Proposed Residence Lot 6 DP758047 6 Shelley Beach Road East Balling

## DAP ASSESSMENT REPORT

File Reference	DA: 2015/402	0 7 OCT 2015 RECORDS	$\sim$
Applicant	Mr M Walton	LUCHUS	
Property	Lot: 6 Sec: 96 DP: 758047, 6 \$	Shelly Beach Road EAST	BALLINA
Proposal	Conversion of existing shed to	a Secondary Dwelling	
Effect of Planning Instrument	The land is R3 Medium Dens the Ballina Local Environm Development Control Plan (DC	ental Plan (BLEP) and

Conversion of existing shed to a Secondary Dwelling

SITE PLAN

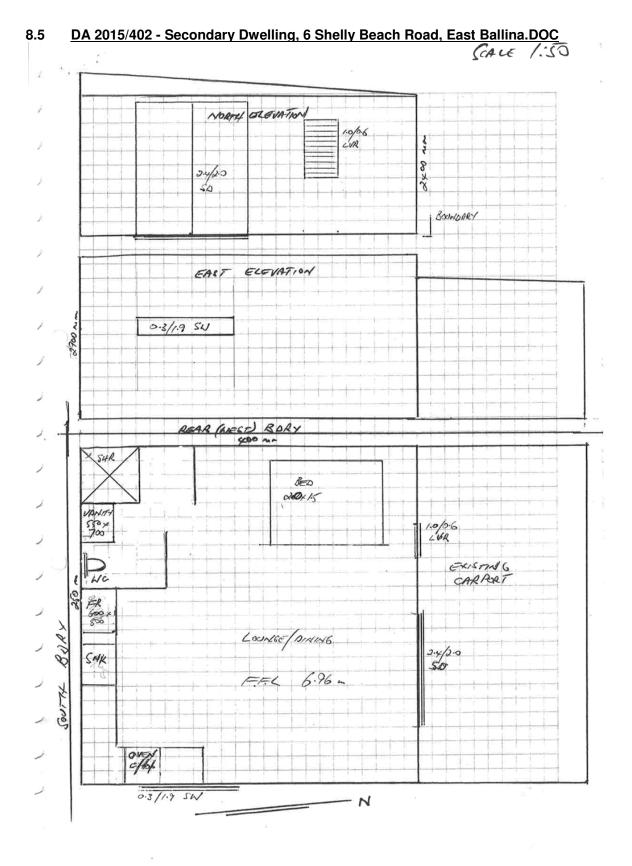
- 1. The building is 200mm from the side boundary whereas Part 9 of the SEPP requires 900mm;
- 2. The building is 400mm from the rear boundary whereas Part 10 of the SEPP requires 3 metres.

1. External walls do not comply with the Fire Separation requirements of the BCA for a Class 1 building.

The building does not satisfy the requirements of the Building Code of Australia in regard to fire safety matters as the weatherboard external wall has no fire rating.

It was also noted that the reserve at the rear appears to be well used and maintained. Variation to the SEPP to allow a secondary dwelling on a 400mm setback instead of the 3 metres required by the SEPP was an intrusion into the users of the reserve. The Panel noted that the shed could be brickveneered or provided with an alternative fire rated material that would satisfy the BCA.

- 1. Part 3.7 of the Building Code of Australia Class 1 and 10 Buildings regarding Fire Separation;
- 2. Parts 9 and 10 of the State Environmental Planning Policy (Affordable Rental Housing) 2009 regarding side and rear boundary setbacks;
- 3. Element C of Ballina Shire Development Control Plan 2012 Chapter 4 regarding Building Envelopes.

I am willing to meet BCA requirements on walls to the southern and western boundaries. I am are also aware that the immediate neighbour to the south does not object to the development. The existing/proposed building is 200-300mm from the south/west site boundararies. The western boundary of the site is a adjacent to a reserve. I am aware of the height plane condition but feel in this case, given the above conditions, Council may consider waiving this requirement.
